Alabama Port Authority
Addendum to R&P or Specification Booklet

Project Name McDuffie New East Electrical Building

Project No. 11734 **Task No.** 02 **Addendum No.** 1

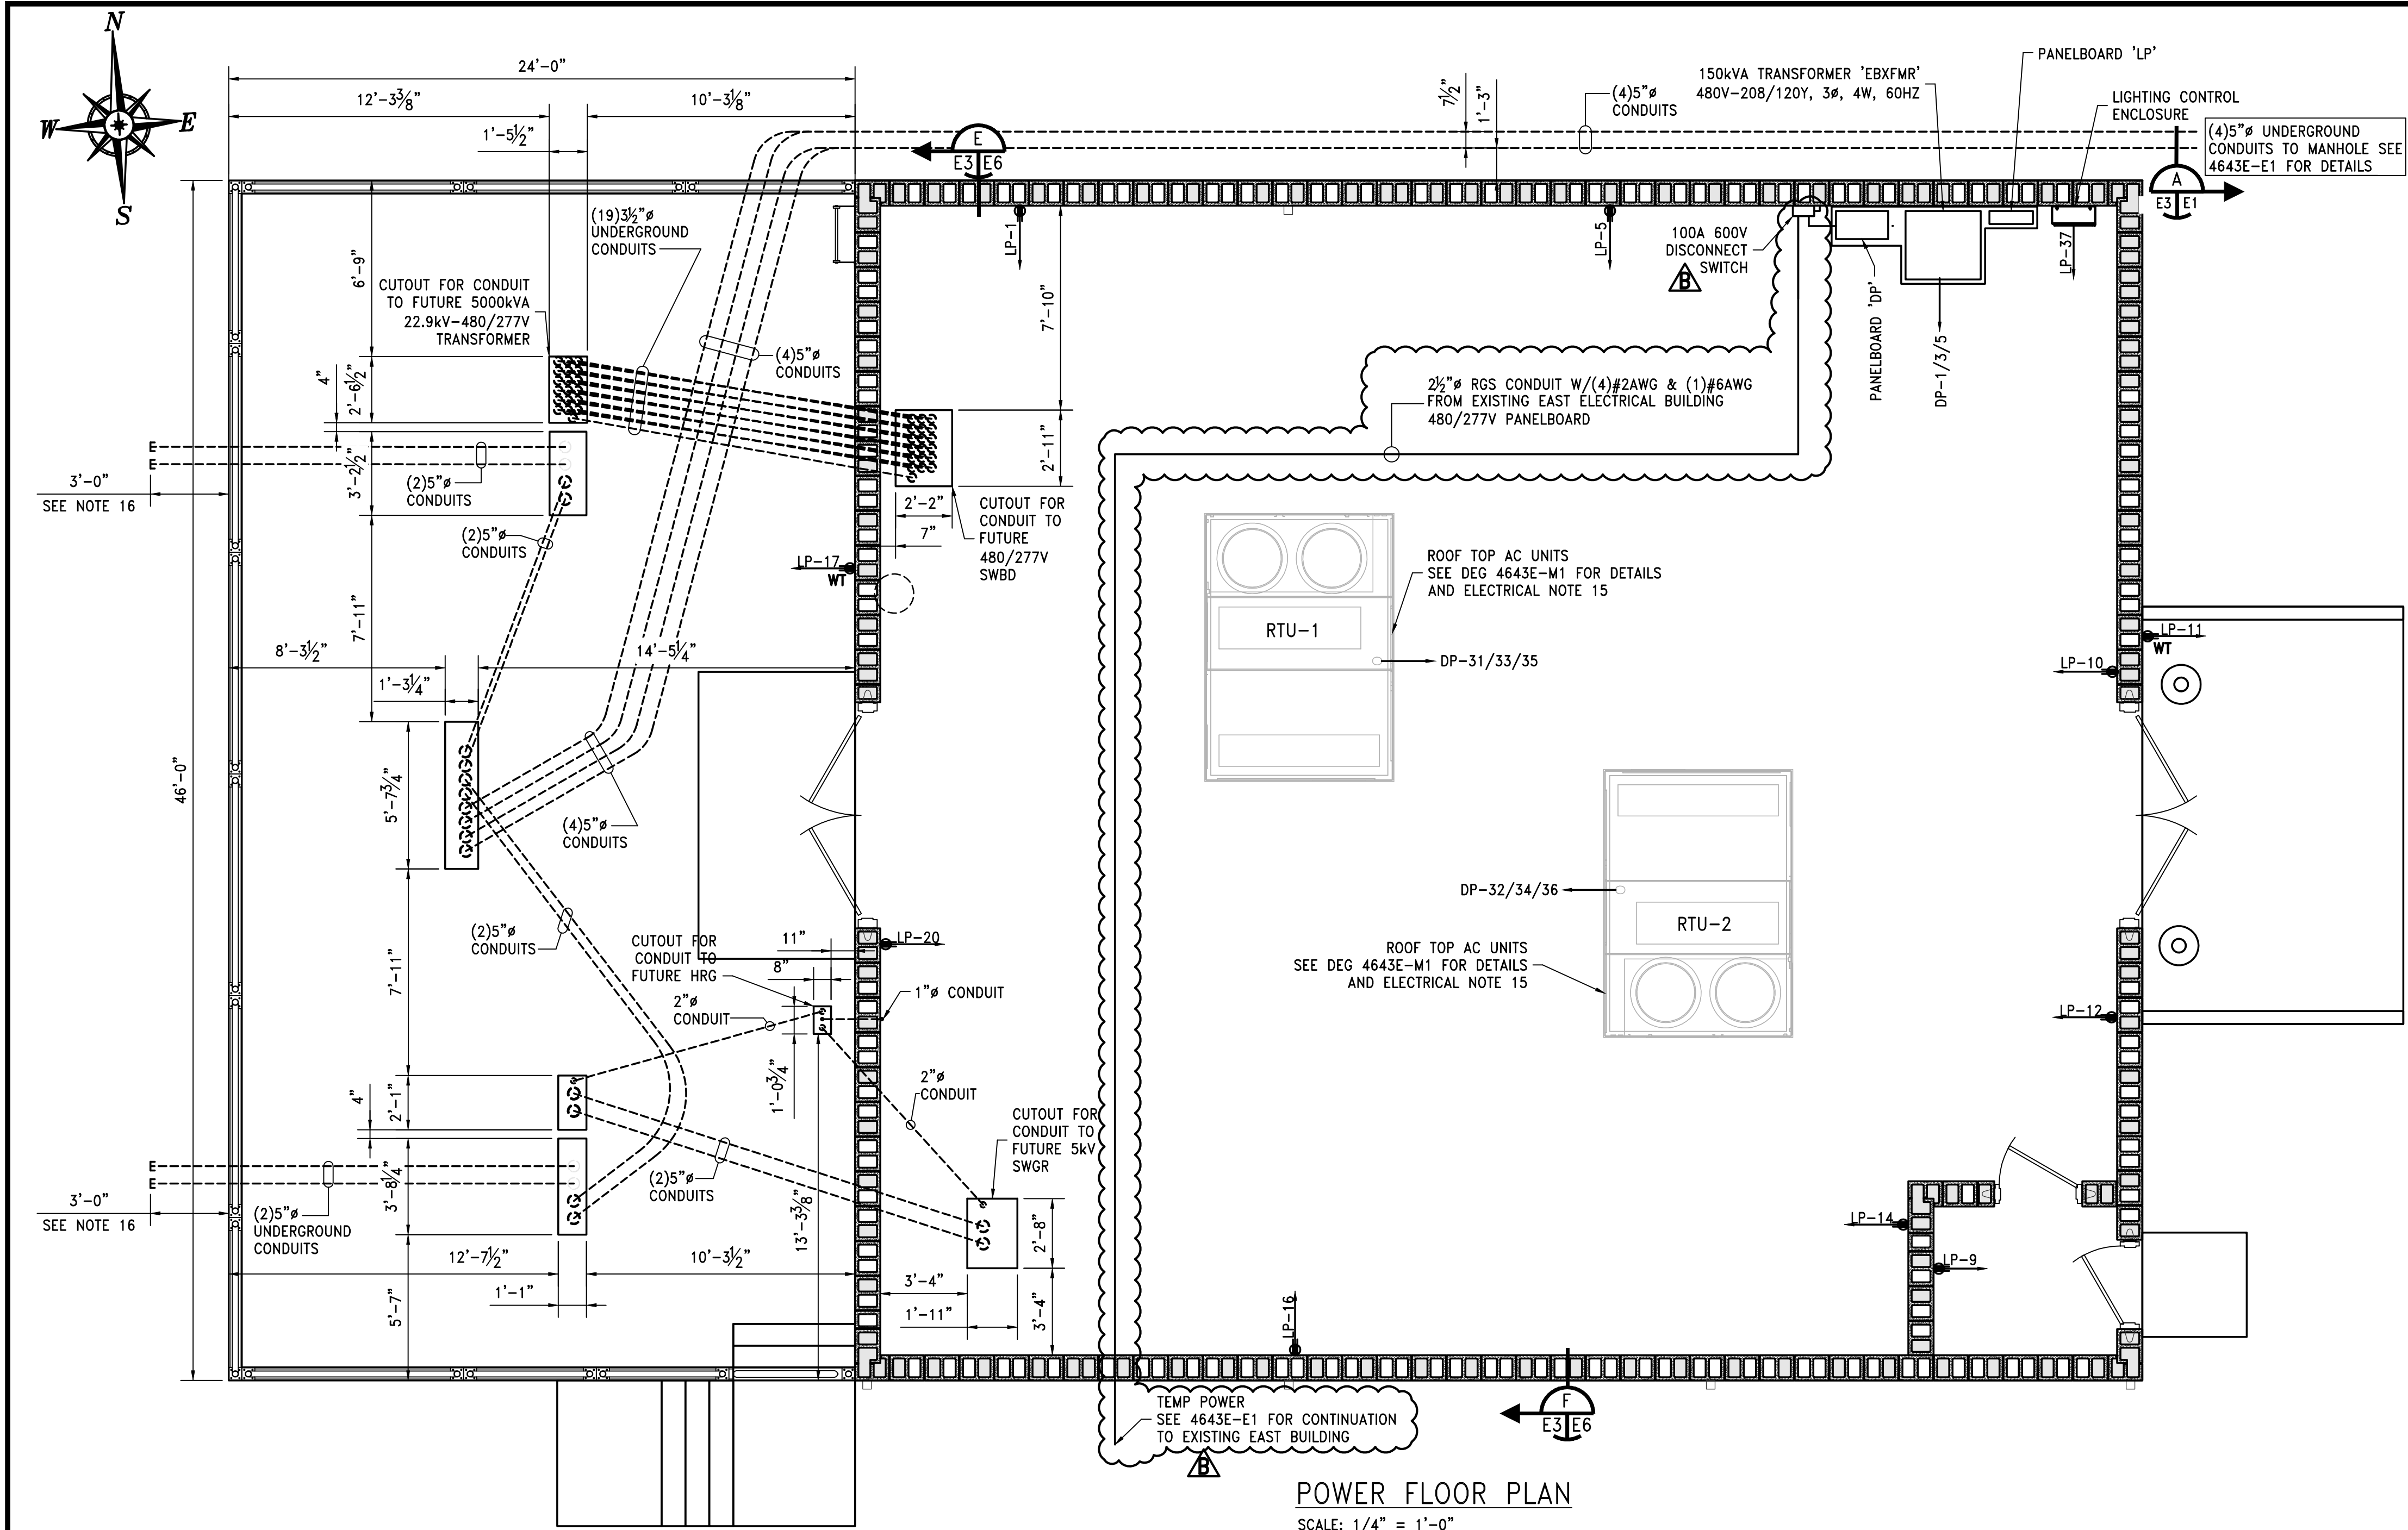
5. CONTRACTOR SHALL FURNISH AND INSTALL TEMPORARY ELECTRICAL SERVICE TO THE NEW EAST BUILDING WITH A UNDERGROUND CONDUIT, 2½" SCHEDULE 80 ELECTRICAL PVC CONDUIT BURIED AT A MINIMUM OF 30" BELOW FINISHED GRADE WITH (4) #2AWG AND #6AWG GRD FROM THE EXISTING EAST BUILDING 480/277V PANELBOARD DP. CONNECT THE CONDUCTORS TO AN EXISTING 100A, 3-POLE CIRCUIT BREAKER IN THE EXISTING EAST BUILDING AND TO THE 100A, 600V DISCONNECT SWITCH FOR PANELBOARD DP. STUB-UP CONDUIT AT THE EXISTING CABLE TRAY AT EXISTING EAST BUILDING AND EXTERIOR WALL NEAR FUTURE CABLE TRAY OPENING IN SOUTH SIDE OF NEW EAST ELECTRICAL BUILDING. ROUTE CONDUIT UP AND INTO NEW BUILDING TO 100A DISCONNECT LOACTED AT NEW PANELBOARD DP.

TITLE	
ELECTRICAL BUILDING POWER FLOOR PLAN	
© CMG ENGINEERS, INC. 2026 - CONFIDENTIAL, VALUABLE, AND PROPRIETARY INFORMATION	DATE 05/27/26 DRAWING NUMBER 4643E-E3

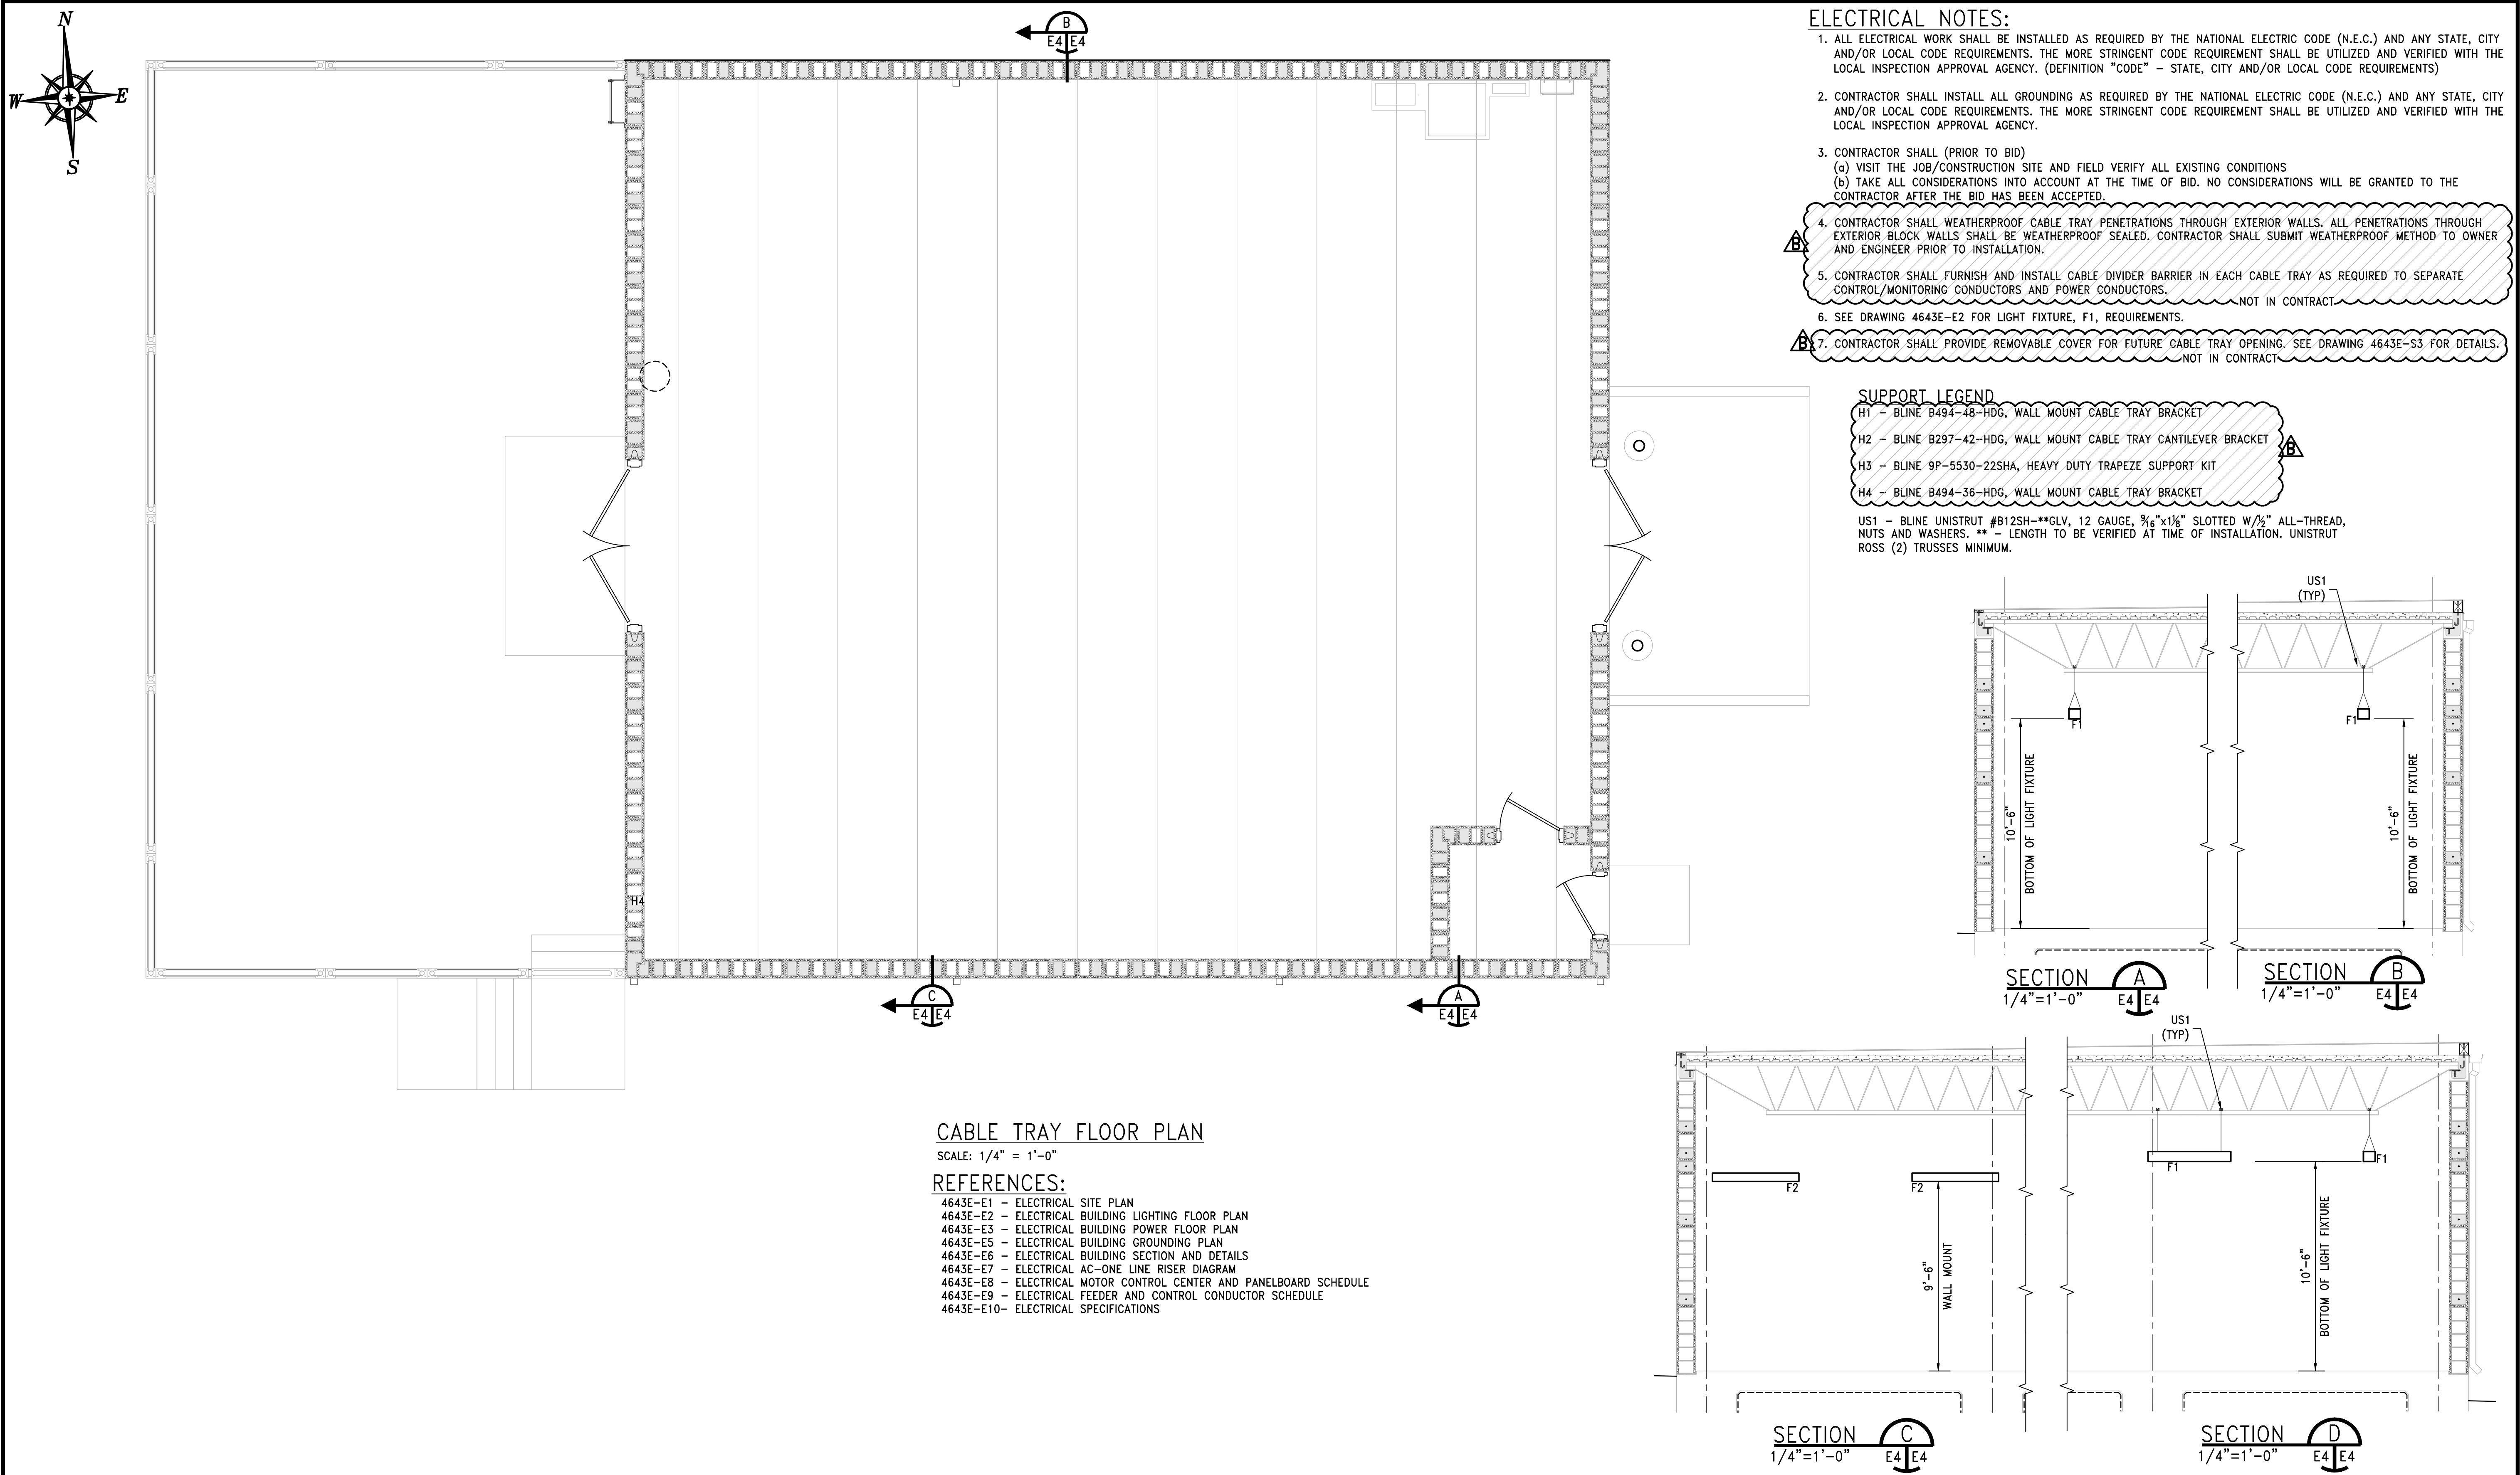
B	ADDED TEMP POWER. ITEMS NOT IN CONTRACT	10/20/26	WES	JJM
A	ISSUED FOR BID	09/11/26	WES	JJM
REV.	DESCRIPTION	DATE	BY	CHK'D

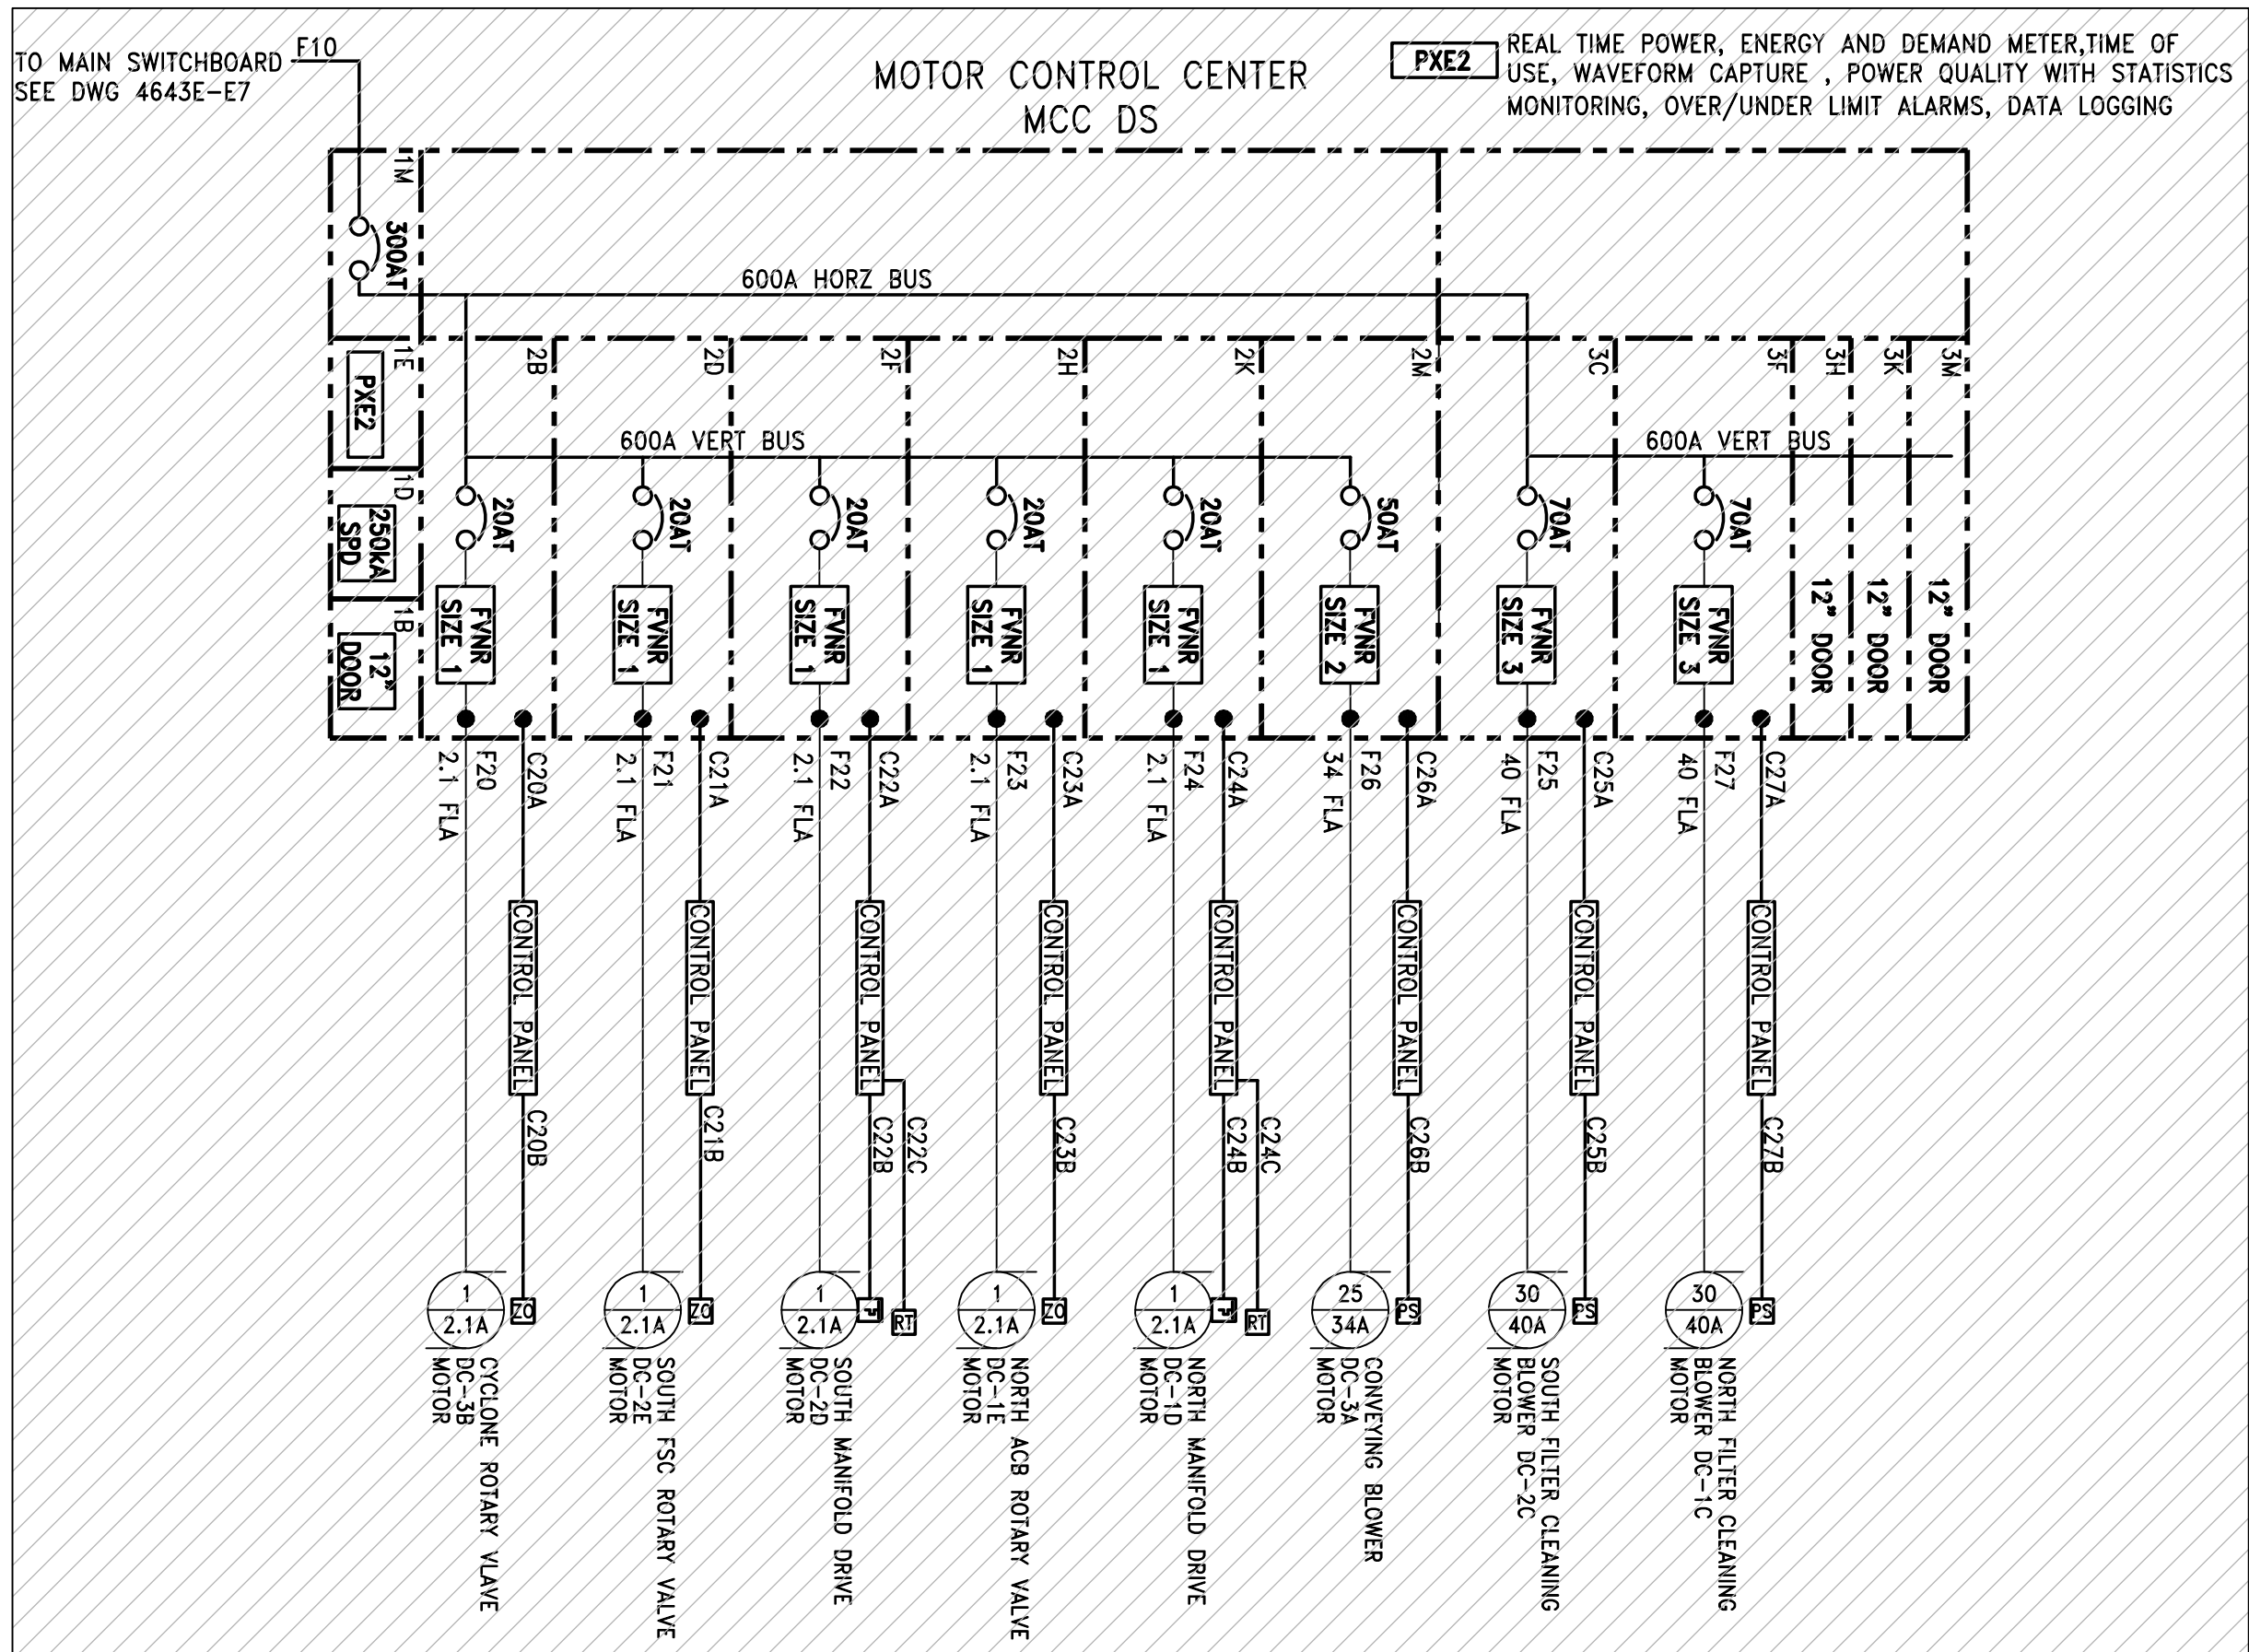
NOT IN CONTRACT

NOT IN CONTRACT

B	ITEMS NOT IN CONTRACT	10/22/26	WES	JJM	
A	ISSUED FOR BID	09/11/26	WES	JJM	
REV.	DESCRIPTION	DATE	BY	CHK'D
